**PRELIMINARY DRAINAGE REPORT
FLYING HORSE NORTH PRELIMINARY PLAN AND
FINAL DRAINAGE REPORT FOR FLYING HORSE NORTH FILING NO. 1**

CCES COMMENT RESPONSES

**PRELIMINARY DRAINAGE REPORT
FOR
FLYING HORSE NORTH PRELIMINARY PLAN
AND
FINAL DRAINAGE REPORT
FOR
FLYING HORSE NORTH FILING NO. 1**

**NOVEMBER 2017
Revised April 2018**

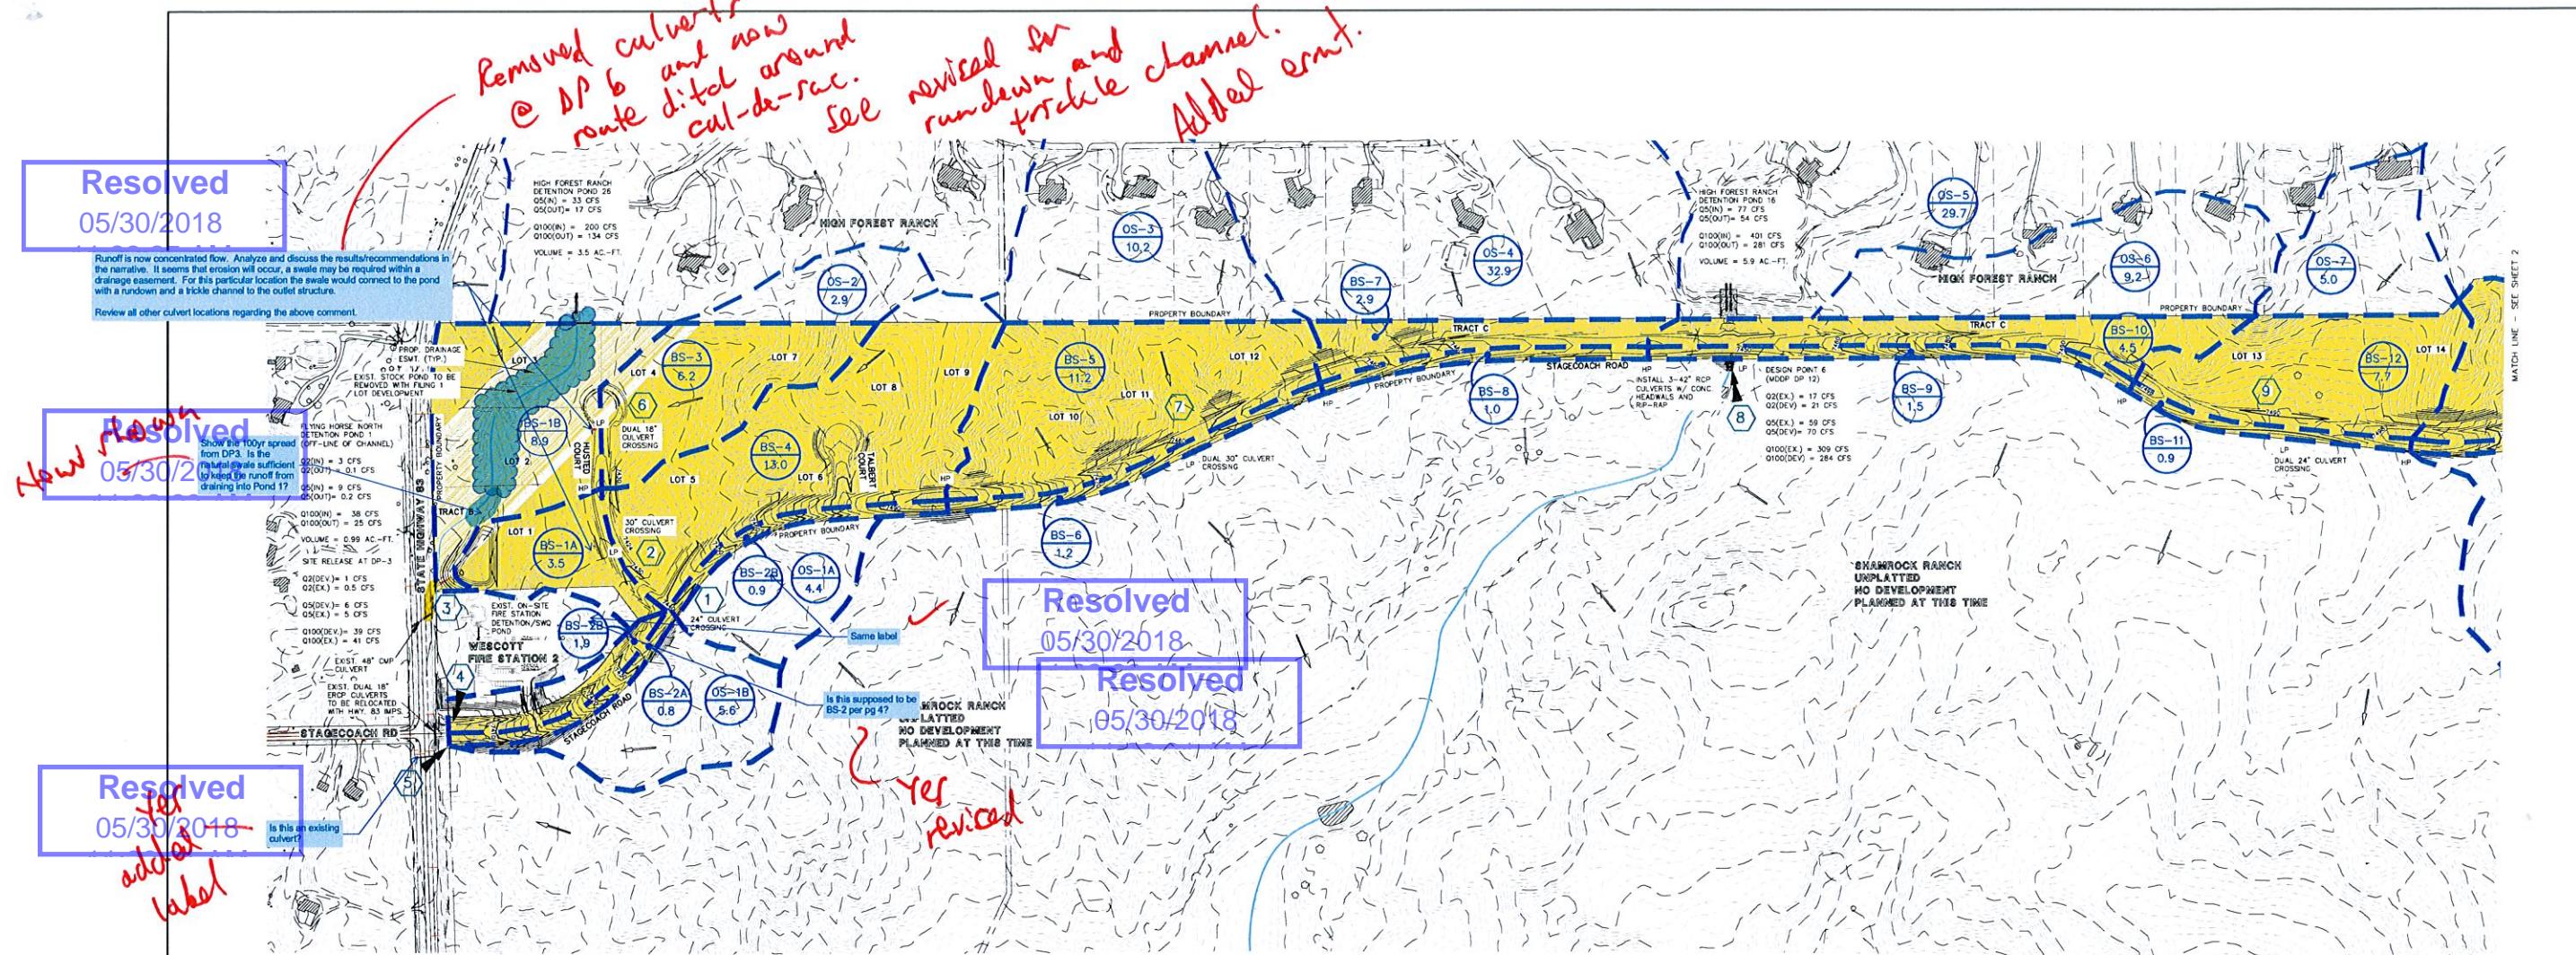
0.9 for full spectrum
detention.
Comment applies
for all Full
Spectrum Pond
design

✓
revised

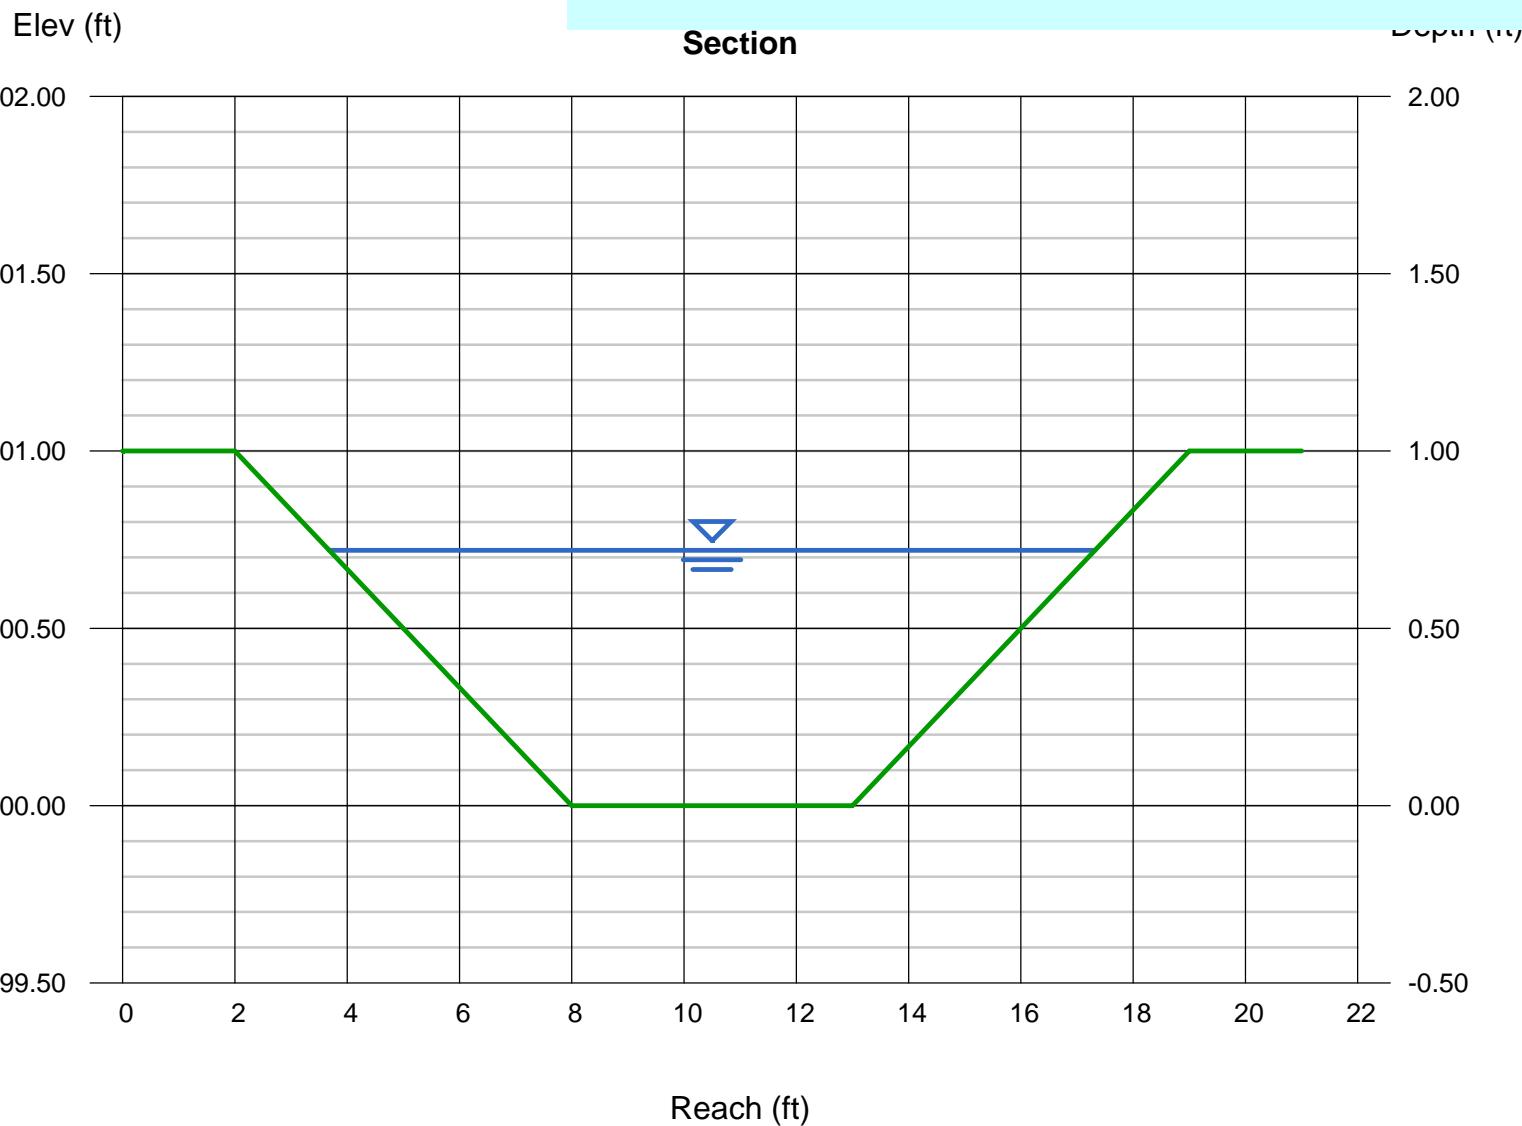
The velocity appears to be greater than permissible velocities for native grass (typically 4 fps for short native grass). Improvements appears to be required for erosion protection. Check the other channel reports and update narrative to discuss the findings.

Include the Froude number in all the channel reports. See DCM 6.5.2
